# Service Technical Information

MODEL NO. XR-H66MD
SUBJECT MD does not operate

REF.No. :G - A0 - 072 - E0

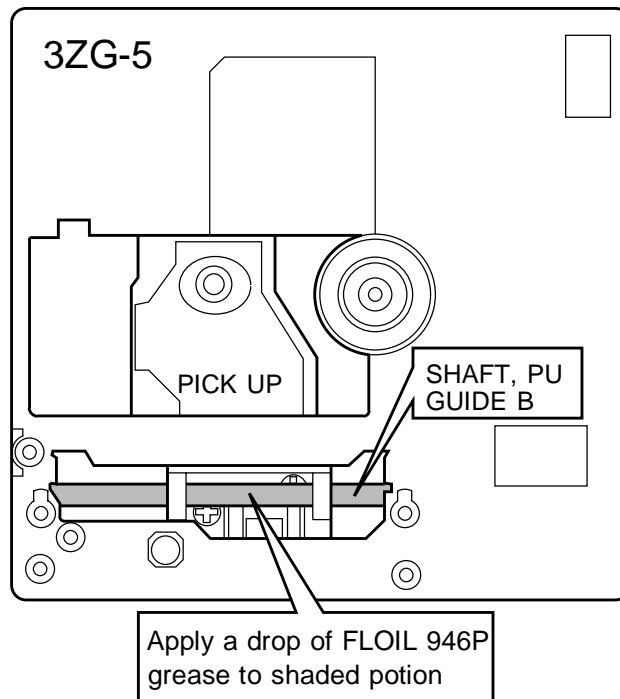
The MD mechanism does not operate because of a PICK UP locking onto a shaft.  
Take the following action against the symptom.

- 1) Remove SHAFT,PU GUIDE B from 3ZG-5.
- 2) Clean the shaft bearing of the PICK UP.
- 3) Replace SHAFT,PU GUIDE B with new one.
- 4) Apply grease (FLOIL 946P) to specified potion of the shaft.  
(Then, move the PICK UP a few times for lubrication.)

If movement of the PICK UP does not become smooth even after the treatment above, replace the PICK UP with new one.
